Service Letter #: SL09-35A51800

Part/Assembly #: 35A-51800 5.00 X 6.00 (6.00-6) Wheel Assembly, Oil Bath Type.

Float Model/Aircraft Affected: 3400 Amphibious model floats, Float Serial Numbers 508-509 & 512-513.

Fig. 1 – 35A-51620 TSO Placard. Incorrect Placard.

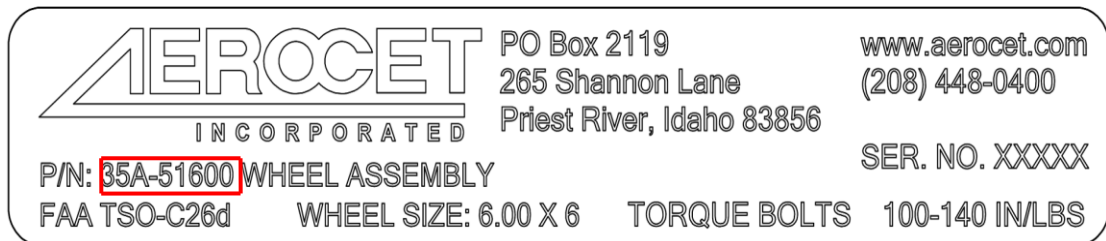
Symptom: Incorrect placard installed on 35A-51800 5.00 X 6.00 (6.00-6) Wheel Assembly, Oil Bath Type.

A small batch of part 35A-51800 (Wheel Assembly, Oil Bath Type) were incorrectly labeled with part 35A-51620 (TSO Placard). Correct part is 35A-51820 TSO Placard, Aerocet 35A-51800 Wheel Assembly.

Note: To replace placard use a non-metallic object with pointed edge to lift one corner of the existing placard, once corner is lifted remove by hand. Clean the wheel surface with acetone to remove all residual adhesive. Incorrect placard is shown in Fig. 1 and correct TSO Placard is shown in Fig. 2.

Replace incorrect 35A-51620 Placards with correct 35A-51820 TSO Placard as shown in Fig 3. This is to be accomplished during the next scheduled maintenance period, not to exceed the next 100 hour or annual inspection.
